Access Compliance Report

Public Rights-of-Way (Curb Ramps)

Intersection ID: 2952	Main Street: CREEK_BREEZE_RD	Cross Street: GREEN_PASTURE_RD	Location:	N
ADA ID: C12FBBADB53	Ramp Type: PerpDiag	Initial Pass/Fail: Fail	Overall Compliance: No	Severity Score: 12.5
Codes/Mitigation Info/Possible Solution		Field Measurements/Component Compliance

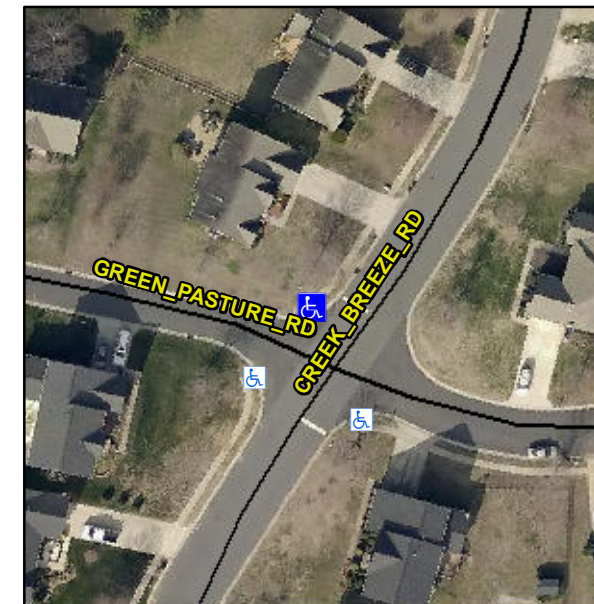
Not Found, R304.2.2

Compliance	Description	Data	Compliance	Description	Data
N/A	Ramp Length (in)	45.0	No	Ramp Slope (%)	10.3
Yes	Ramp Width (in)	68.0	Yes	Ramp XSlope (%)	0.6
N/A	Flare Type LT	N/A	N/A	Flare Type RT	N/A
N/A	Flare Slope LT (%)	N/A	N/A	Flare Slope RT (%)	N/A
N/A	Flare Traversable LT?	N/A	N/A	Flare Traversable RT?	N/A
N/A	Landing Length (in)	N/A	N/A	DWS Provided?	N/A
N/A	Landing Width (in)	N/A	N/A	DWS Contrast?	N/A
N/A	Landing Slope (%)	N/A	N/A	DWS Length (in)	N/A
N/A	Landing X Slope (%)	N/A	N/A	DWS Full Width?	N/A
N/A	Landing Curb? (Y/N)	N/A	N/A	DWS Offset (in)	N/A
N/A	Shared Landing?	N/A			
N/A	Gutter Ponding?	N/A	N/A	Gutter Slope (%)	N/A
N/A	Gutter Lip Ht (in)	N/A	N/A	Gutter X Slope (%)	N/A
N/A	Painted X Walk1?	No	N/A	Painted X Walk2?	No
	X Walk 1 Direction	To SW		X Walk 2 Direction	To SW
N/A	X Walk 1 Width (in)	N/A	N/A	X Walk 2 Width (in)	N/A
	X Walk 1 Slope (%)	1.8		X Walk 2 Slope (%)	0.3
	X Walk 1 X Slope (%)	0.9		X Walk 2 X Slope (%)	0.8

Remove & Replace Curb Ramp With Two New Directional Ramps or Equivalent.
